SERVICE INFORMATION LETTER NO. 0189

- DATE: February 4, 2019
1. SUBJECT: Magneto Retard Terminal P-Lead Insulator
2. MODEL: F-28C, F-28C-2, F-28C-2R, F-28F, F-28F-R, 280C, 280F, and 280FX
3. EFFECTIVITY: F-28F S/N 832 and prior; 280FX S/N 2158 and prior; any F-28C, F-28C-2, F-28C-2R, F-28F, F-28F-R, 280C, 280F, and 280FX that may have had the P-lead insulator changed in the field
4. BACKGROUND:

Figure 1. Timing index marks extended onto the ring gear

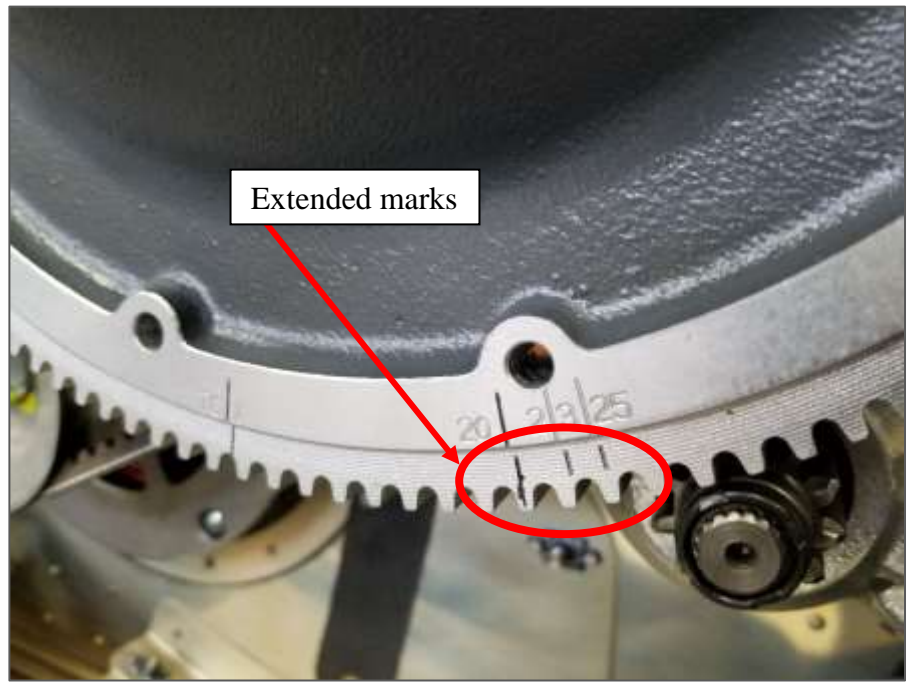
NOTE: The ignition timing marks are stamped into the starter ring gear support assembly and not actually on the ring gear. To aid in setting the magneto timing, it may be advisable to extend the marks onto the ring gear using a fine Sharpie® or similar marker (Figure 1).

Figure 2. P/N 10-382812 Rubber Insulator

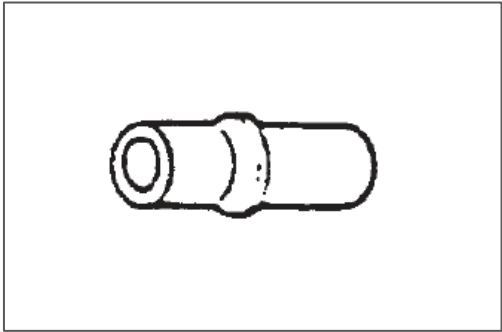
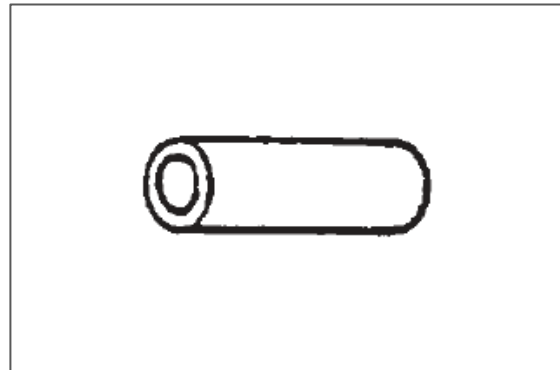
The magneto retard terminal insulator may be either phenolic or soft rubber. The soft rubber insulator is generally used in pressurized magnetos. It forms a tight seal but the compressed insulator may hold the wire insulation and prevent the lead from seating on the terminal and making proper electrical contact. The phenolic insulator will not trap the wire insulation so the lead will make better contact with the terminal. The aircraft with the serial numbers listed above were assembled with a soft rubber insulator (Figure 2). Enstrom recommends checking for this rubber insulator and, if installed, replacing with a phenolic bushing to allow the lead to seat properly.

At the next 100 hr/annual inspection, determine if the P-lead insulator is rubber. If so, replace P/N 10-382812 rubber insulator with P/N 10-157212 (Kit P/N 10-157208) bushing in accordance with paragraph 6.

6.6 Slide the rubber P-lead insulator (P/N 10-382812) (Figure 2) off of the wire and slide the phenolic insulated bushing (P/N 10-157212) (Figure 3) onto the wire.
